VIRGIL C. SUMMER NUCLEAR STATION, UNIT NO. 1

AMENDMENT TO FACILITY OPERATING LICENSE

Amendment No. 37 License No. NPF-12

ATTACHMENT TO LICENSE AMENDMENT NO. 37

Figure 2.1-1
Reactor Core Safety Limit - Three Loops in Operation

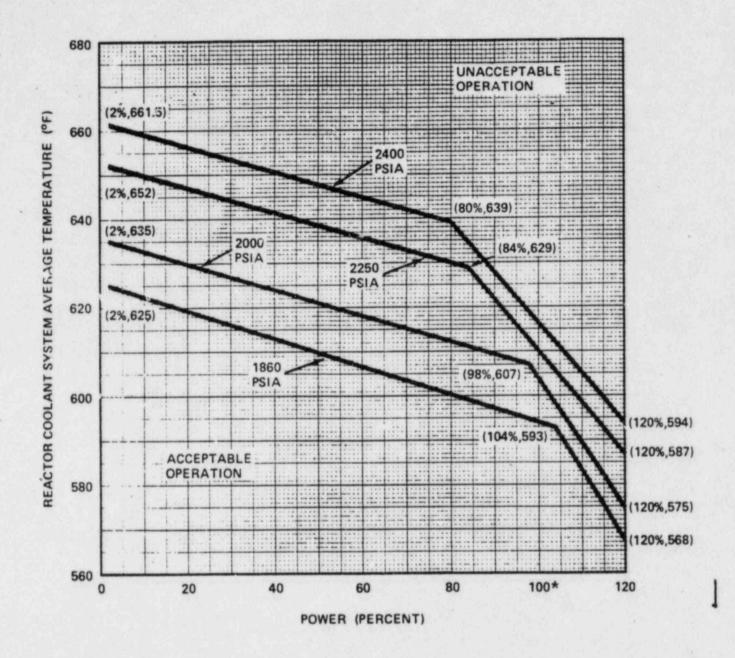
*When operating in Region III of Technical Specification 3.2.3 (Figure 3.2-3), the restricted power level must be considered 100% RTP for this figure.

Figure 3.2-3 RCS FLOW RATE VERSUS R

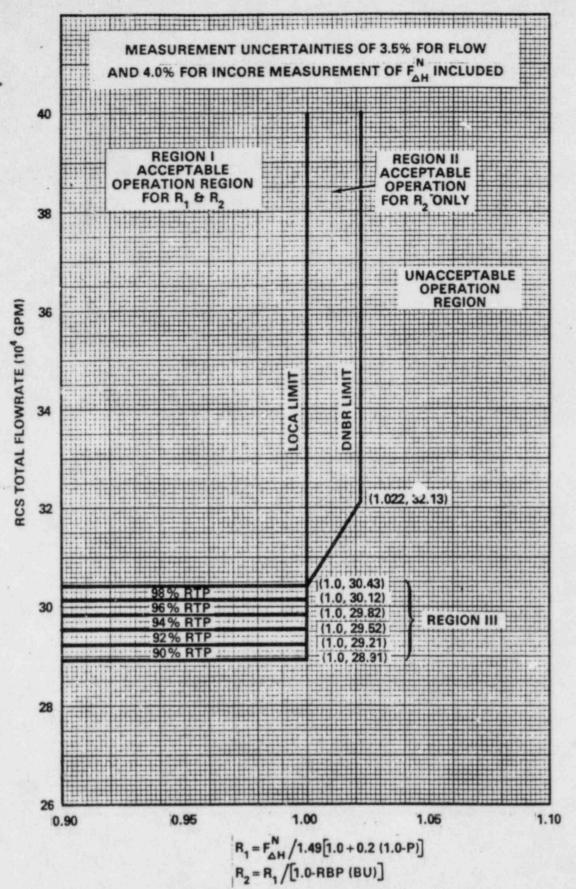
NOTE: When operating in Region III, the restricted power levels shall be considered to be 100% of Rated Thermal Power (RTP) for Figure 2.1-1.
